KENDA DAM
WESTMORELAND COUNTY, COMMONWEALTH OF PENNSYLVANIA
(NDI No. PA 00459,
PennDER No. 65-118), Old River Bridge
Number

PHASE I INSPECTION REPORT
NATIONAL DAM SAFETY PROGRAM

Kenda Dam, Westmoreland County, Pennsylvania
NDI No. PA 00459, PennDER No. 65-118
Tributary of Little Sewickley Creek
Inspected 14 December 1979

PLATE 3

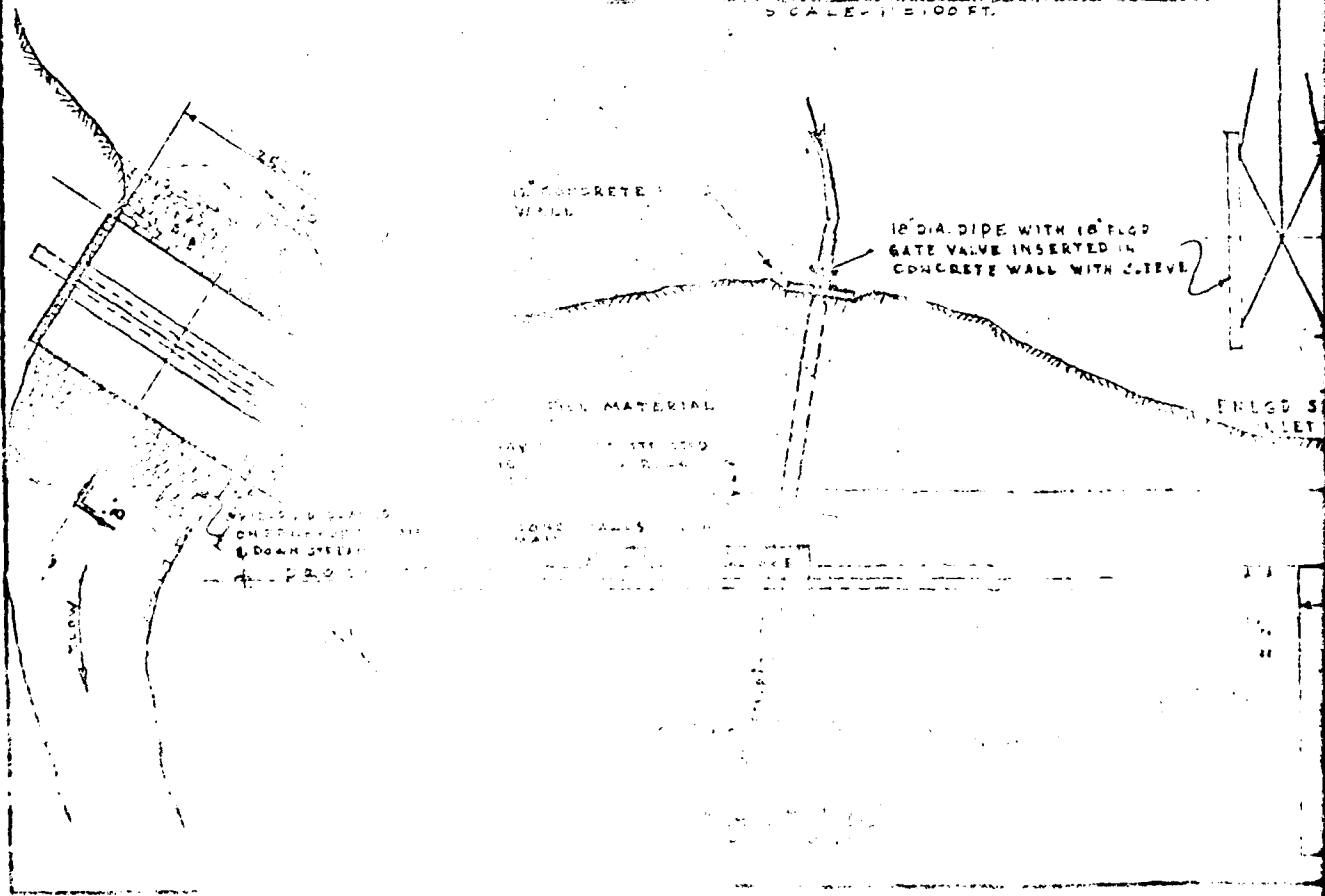
There are a number of discrepancies between the "as built" conditions for the dam and those shown on the design plans in PennDER's file. Some of these differences resulted from the owner supplying PennDER and the building contractor with two different sets of plans, neither of which apparently contained all of the revisions made in the design of the dam. These discrepancies and other changes made after completion of the dam are listed below.

- 1) The spillway was designed to be 25 feet wide in order to have the capacity required by PennDER. It was constructed only 23.8 feet wide.
- 2) The three 18 inch corrugated metal pipes which run through the spillway weir are not shown on the design plans.
- 3) A steel channel was supposed to be installed along the crest of the spillway weir to

protect the concrete. Instead, the contractor flattened the crest of the weir and installed the steel channel to form a sharper weir crest. The edge of the steel channel forms the crest of the weir.

- 4) The crest of the dam is shown on the design plans as being at Elevation 1027.0 feet M.S.L., 6 feet above the crest of the triangular weir. The top of dam profile surveyed during the field inspection shows that none of the embankment is at this elevation. The average crest elevation is currently 1024.0 feet M.S.L., the minimum crest elevation is 1022.8 feet M.S.L.

- 5) The control for the outlet works is shown on the design plans as being an 18 inch gate valve. This was changed during construction to two 12 inch gate valves.

- 6) The original crest width of the dam was designed to be 10 feet. With the addition of the fill to the downstream side of the embankment, the crest width currently ranges from 10 feet at the spillway to over 40 feet at several sections. The side slopes of this fill is also much steeper than the design slope for the embankment (ranging from 1H:1V to 1.5H:1V as compared with the design slope of 2H:1V).

- 7) Riprap protection for the entire length of the spillway discharge channel was also part of the original specifications for the dam. No evidence of any protective measures in the discharge channel was observed during the inspection.

- 8) The riprap protection for the upstream face of the embankment was supposed to be placed from the toe of the slope to two feet above normal pool. The water level at the time of the inspection was 1.2 feet above normal pool, and, in several areas, was above the level of the riprap protection.

- 9) Cut-off walls for the spillway/embankment and spillway/abutment junctions are shown on the design drawings; however, no cut-off walls were observed in the field.

NOTE: THIS DESIGN DRAWING IS NOT REPRESENTATIVE OF THE "AS BUILT" CONDITIONS. SEE THE TEXT AND FIELD SKETCH FOR "AS BUILT" CONDITIONS.
